BULLETIN 9

PROJECT: Yonkers Community School 35 – Justice Sotomayor

RE: Coordination Drawings – Architectural Floor Plans
Academic Building

Project Name: Yonkers Community School 35 – Justice Sotomayor
 Summary of Adjustments – MEP Coordination – Academic Building

A204

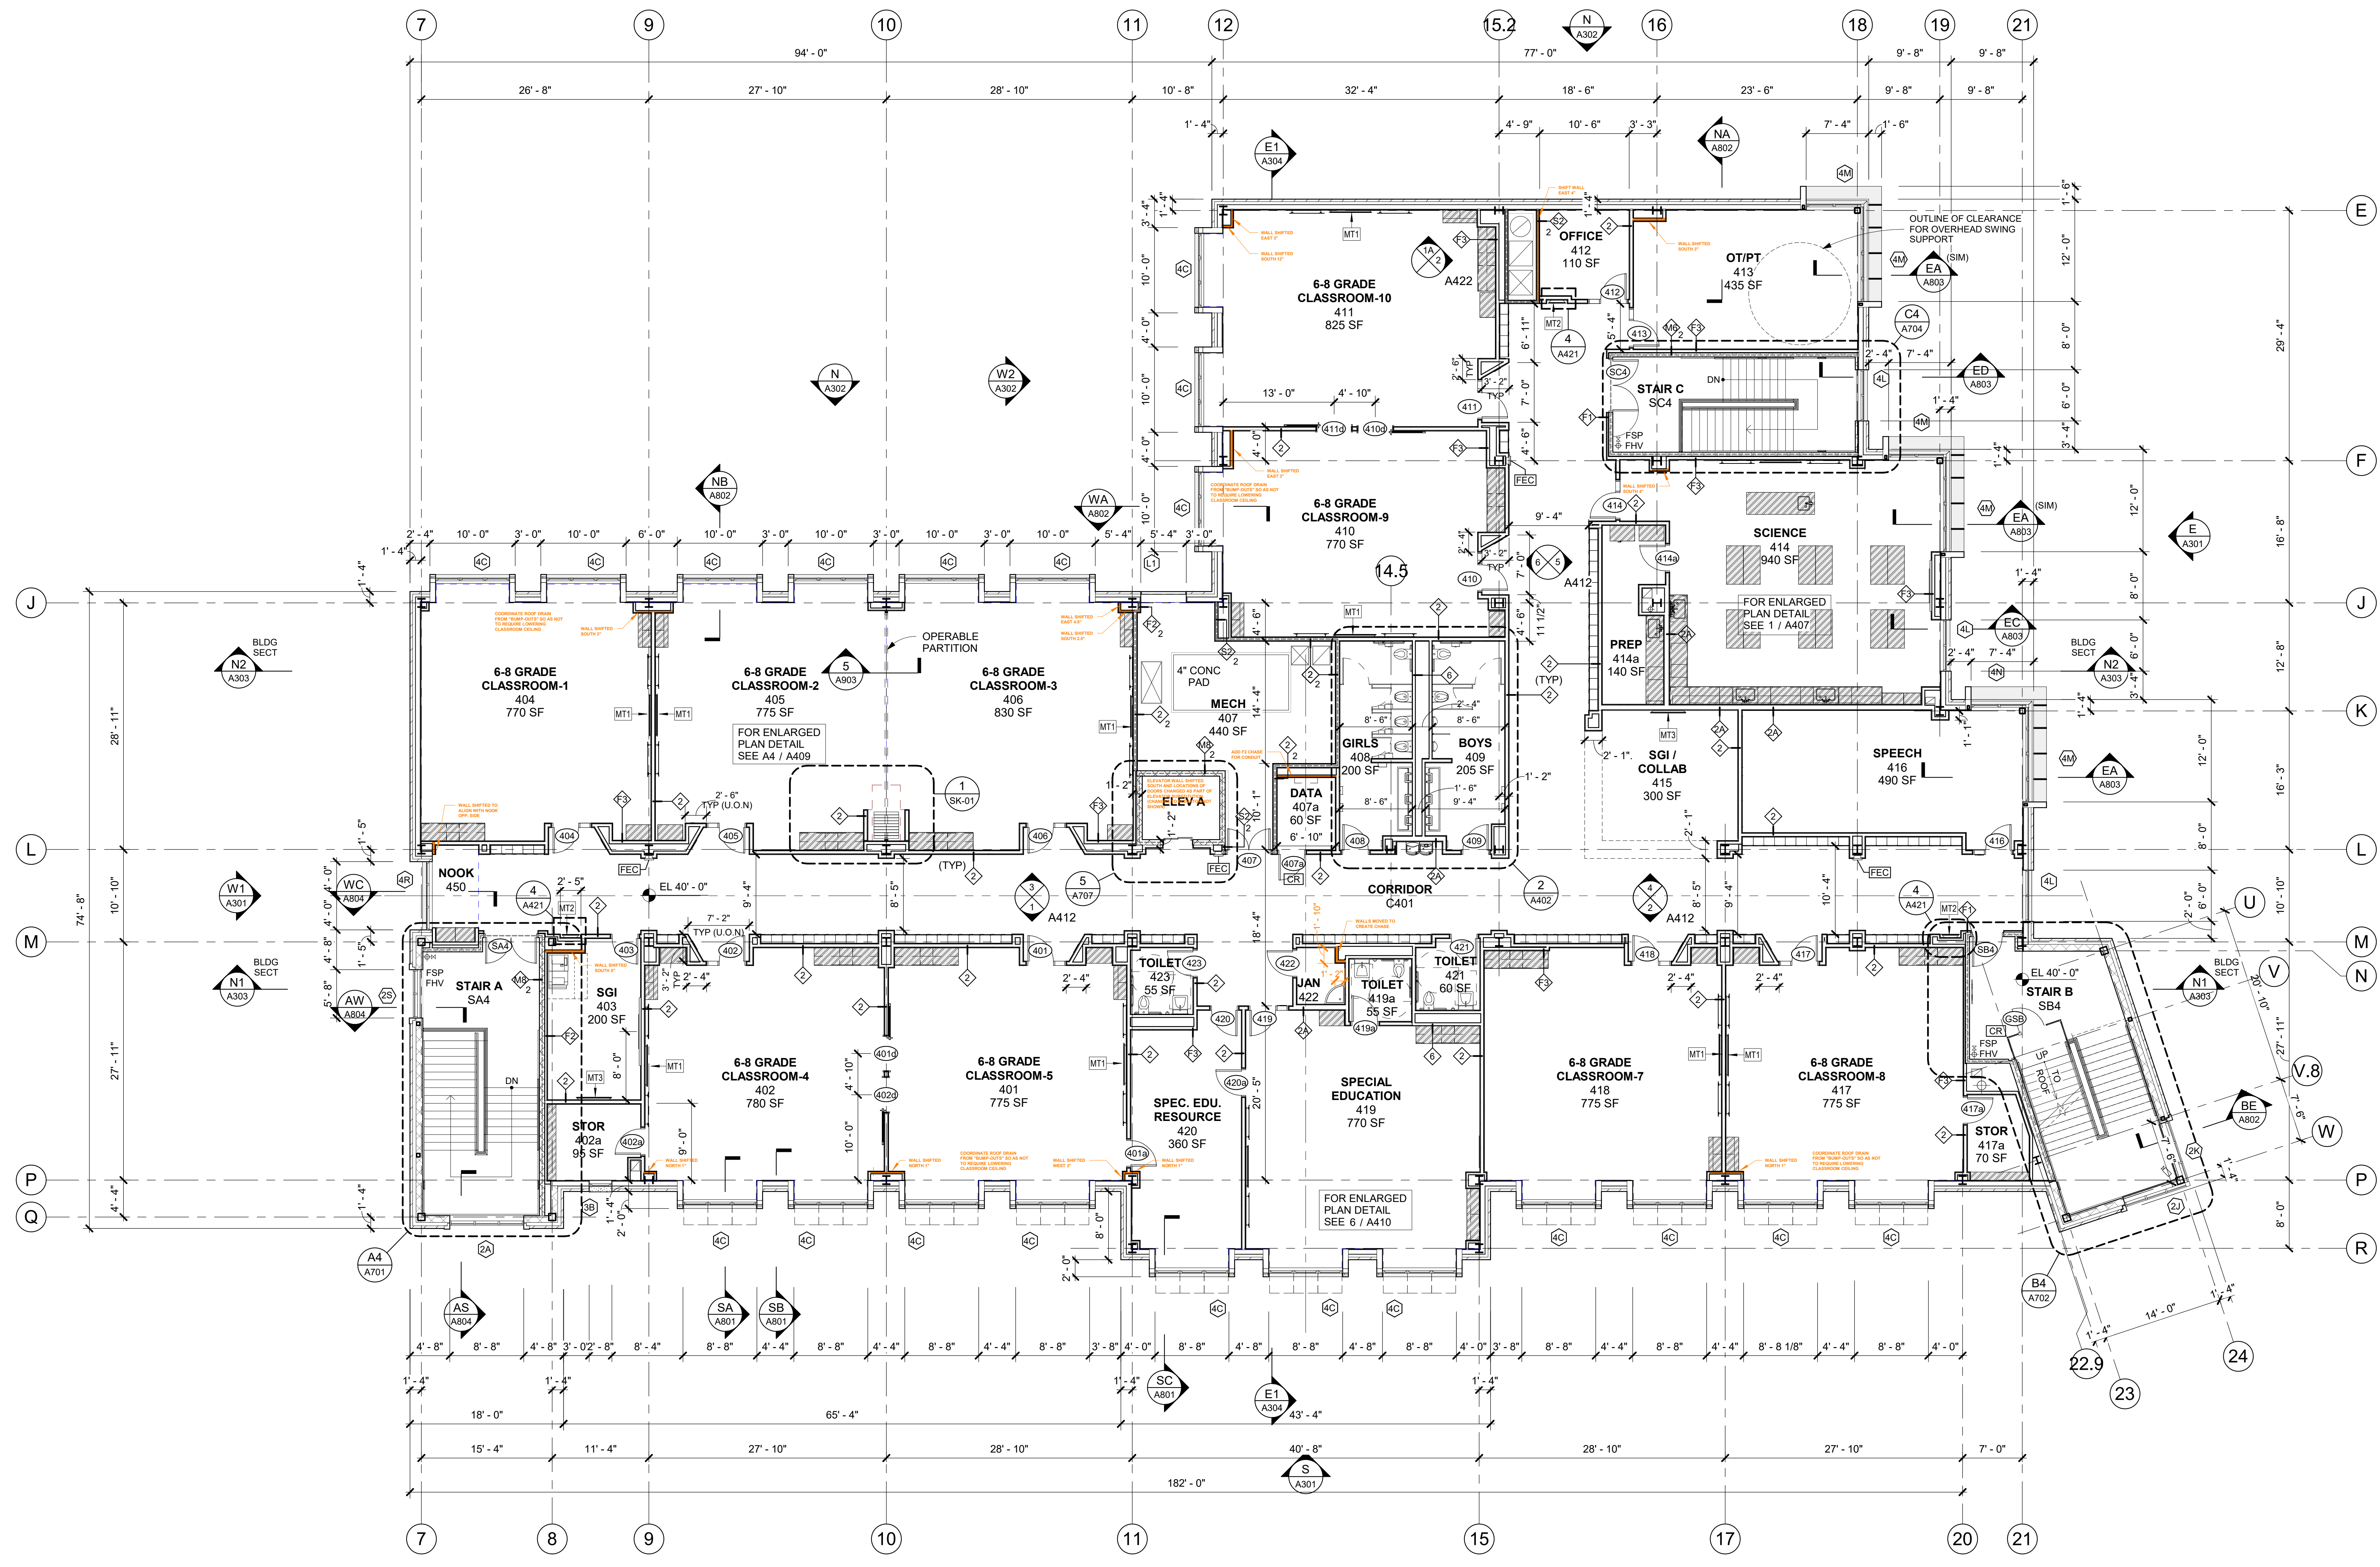
CLASS 401	Shift SE chase wall 3" West and 1" North.	See REVISED SHEET A204
CLASS 401 & 402	Shift South chase wall 1" North	See REVISED SHEET A204
CLASS 402	SW chase wall shifted North 1"	See REVISED SHEET A204

SGI 403	NW chase wall shifted South 5".	See REVISED SHEET A204
CLASS 404 & 405	North chase wall shifted South 3".	See REVISED SHEET A204
CLASS 406	NW chase wall shifted 4.5" West and 2.5" South.	See REVISED SHEET A204
DATA 407a	Add chase wall for conduit.	See REVISED SHEET A204
CLASS 410	Shift Western chase wall 3" East.	See REVISED SHEET A204
CLASS 411	Shift NW chase wall 3" East and 12" South.	See REVISED SHEET A204
OFFICE 412	Shift shaft wall East 4".	See REVISED SHEET A204
OT/PT 413	NW chase wall shifted 3" South.	See REVISED SHEET A204
SCIENCE 414	Shift NW chase wall 4" South.	See REVISED SHEET A204
CLASS 417 & 418	Shift South chase wall 1" North.	See REVISED SHEET A204
JAN 422	Adjust walls to create chase in NE corner.	See REVISED SHEET A204
NOOK 450	Shift chase wall West to align with wall on opposite side of corridor.	See REVISED SHEET A204

CLASS 401, 404, 410, 417	Coordinate elevation of roof drain at roof of bump-outs to ensure pipe is above classroom ceiling. Roof drain in these areas will run above ceiling in lieu of soffit in order for roof drain to get around column. See detail E/A806 for reference purposes.	
--------------------------	---	--
